ORIGINATION FORM

Proposed Revisions to a Standard Plans Index
(Please provide all information – Incomplete forms will be returned)

Index Number: **700-090**
Sheet Number (s): 1 and 2 of 5
Index Title: Dynamic Message Sign Walk-in

DYNAMIC MESSAGE SIGN ASSEMBLY

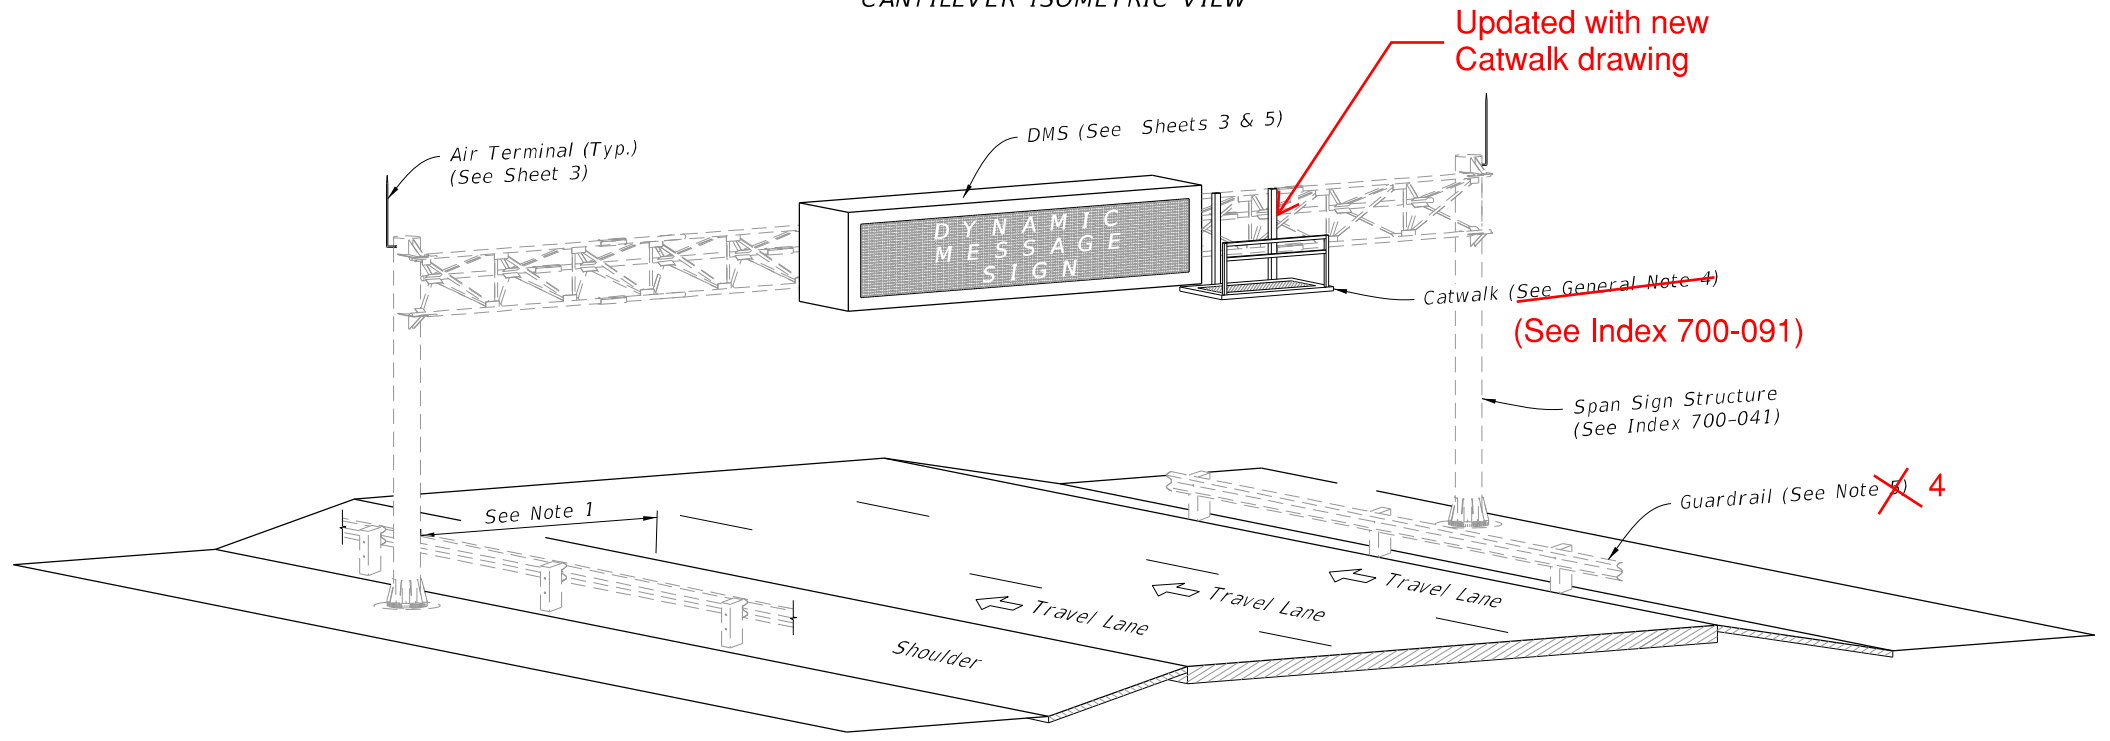
Sheet 1: Deleted General Notes 3.B & 4; renumbered General Notes, Added Note 4 to New Index 700-091; Changed catwalk call-out to reference Index 700-091; Changed Guardrail call-out to reference Note 4; Updated the Catwalk to show new Index drawing.

Deleted Note 3.B and 4.
Moved to New Index 700-091

Updated with new
Catwalk drawing

(See Index 700-091)

Updated with new
Catwalk drawing

(See Index 700-091)

Renumbered

DYNAMIC MESSAGE SIGN GENERAL LAYOUT

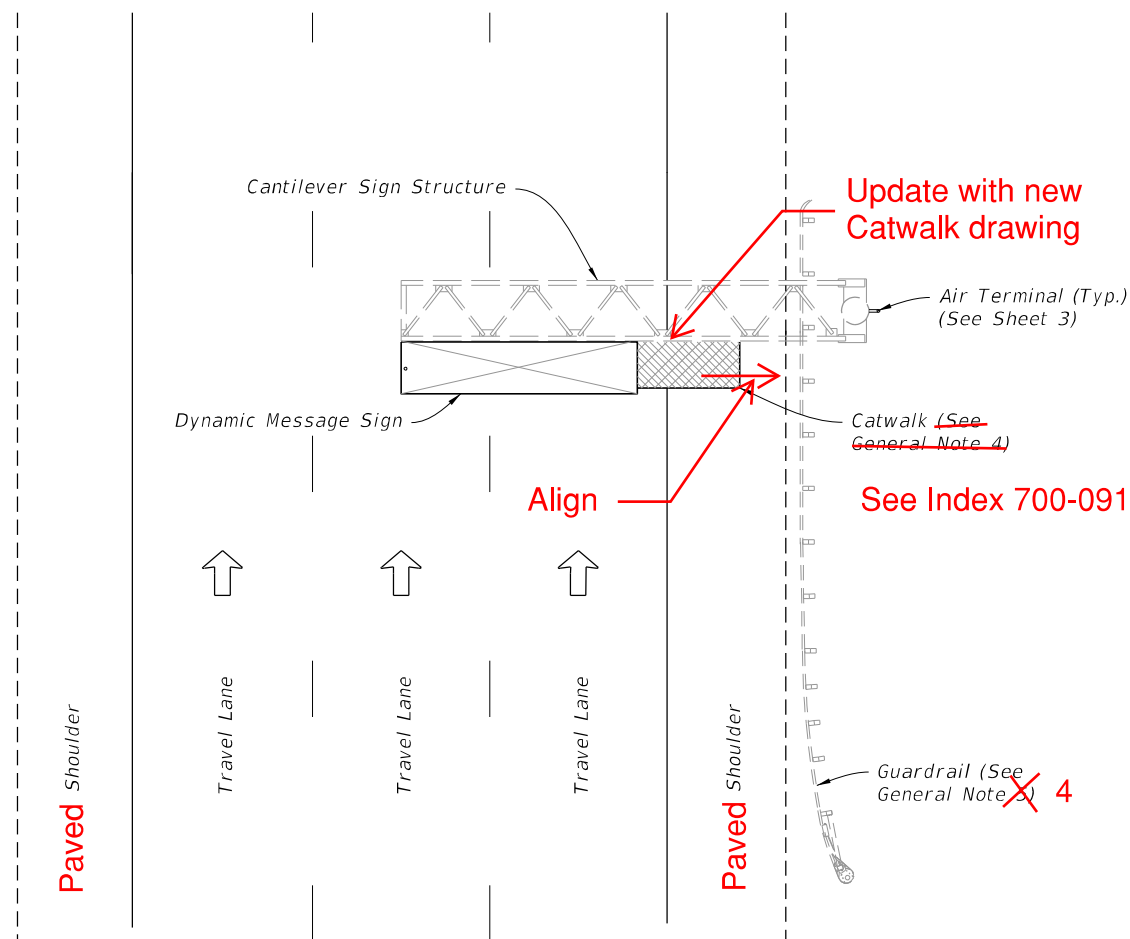
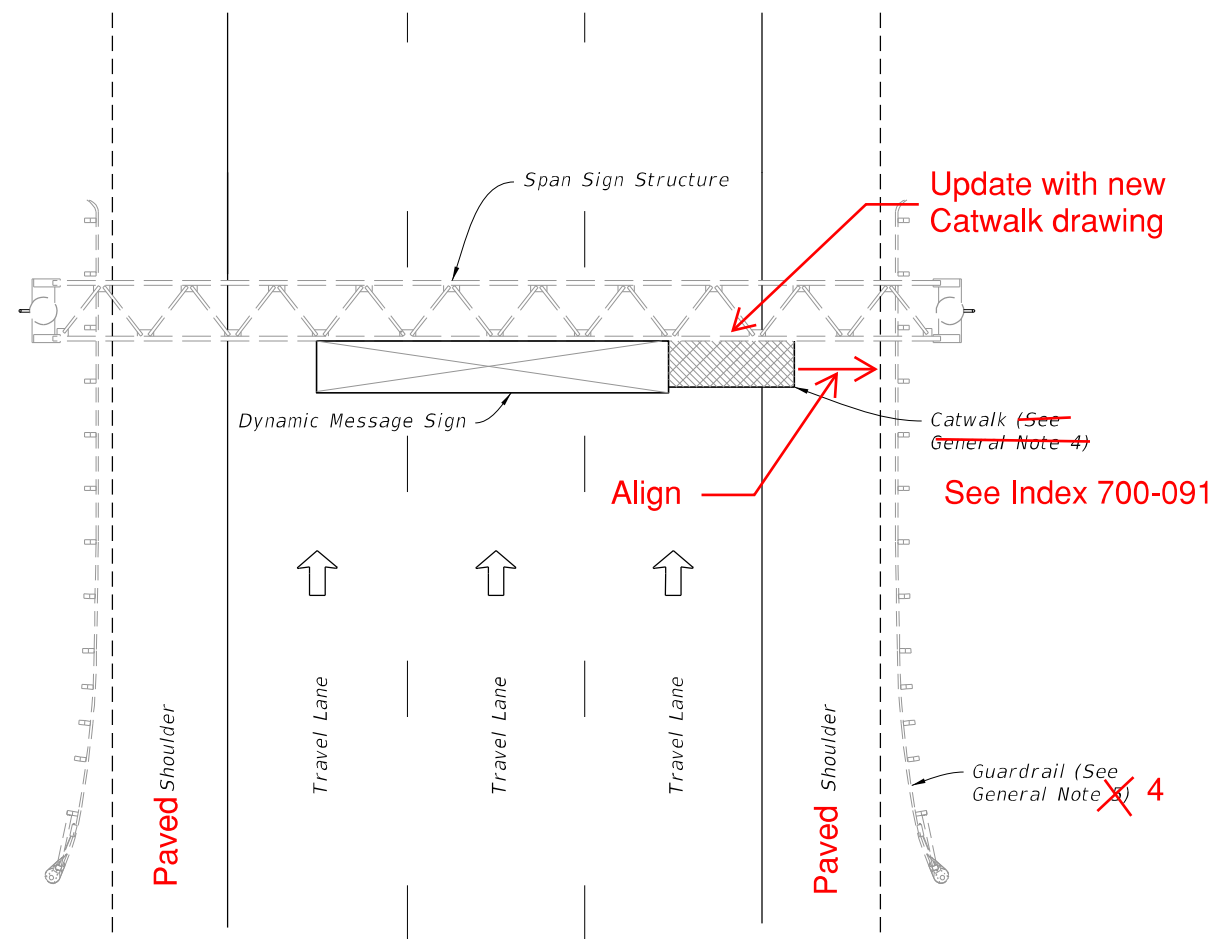
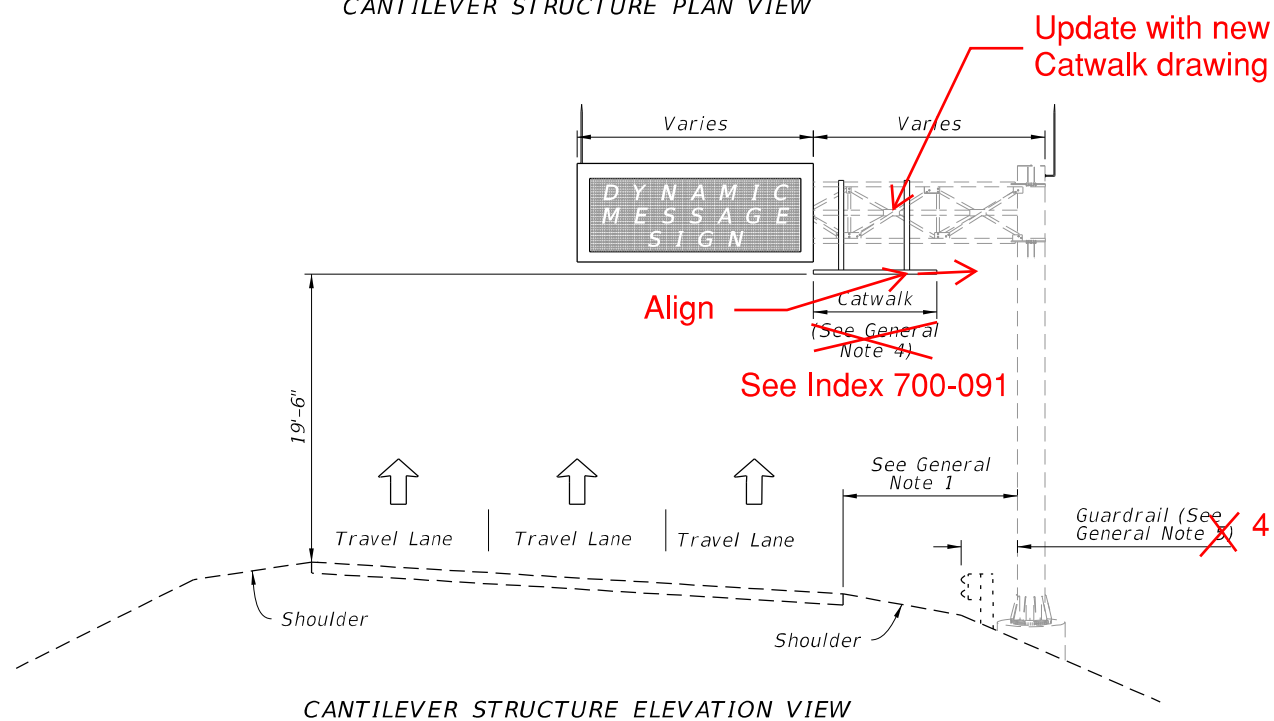
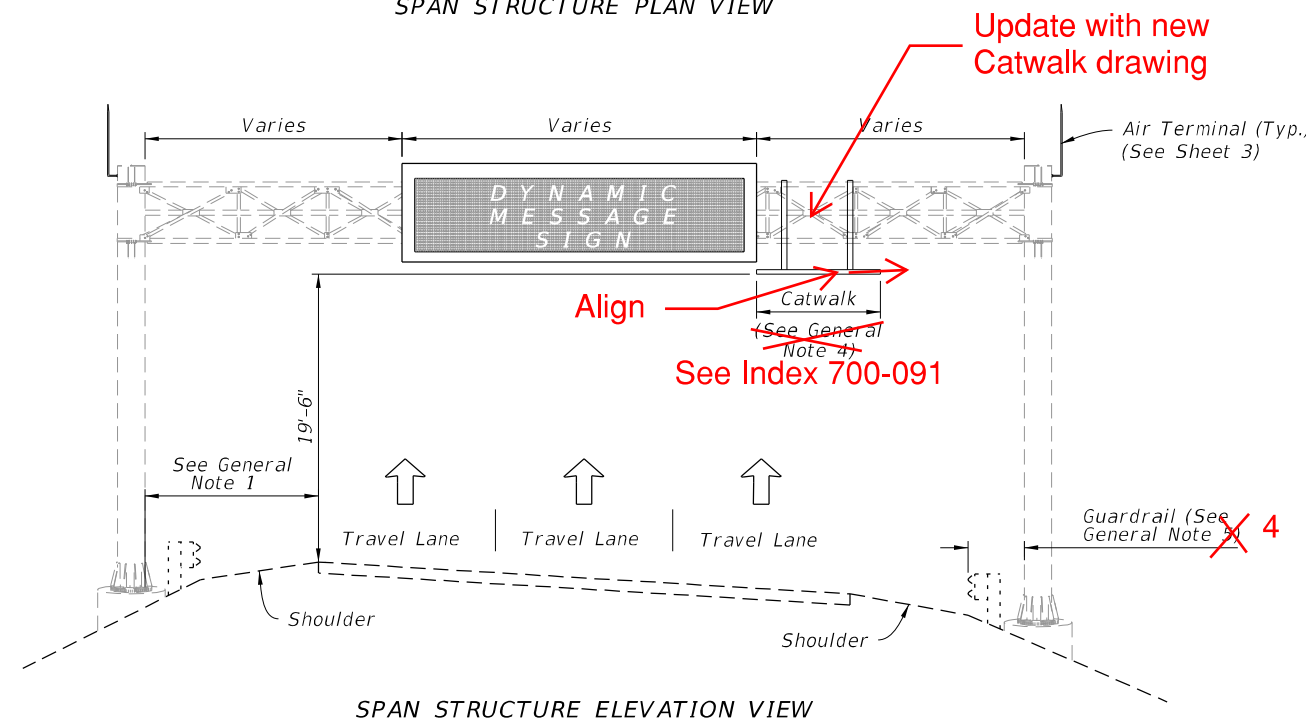
Sheet 2: Changed catwalk call-out to reference Index 700-091; Changed Guardrail call-out to reference Note 4; Updated the Catwalk to show new Index drawing; Changed "Shoulder" to "Paved Shoulder"; Aligned Catwalk to the outer edge of the Paved Shoulder.
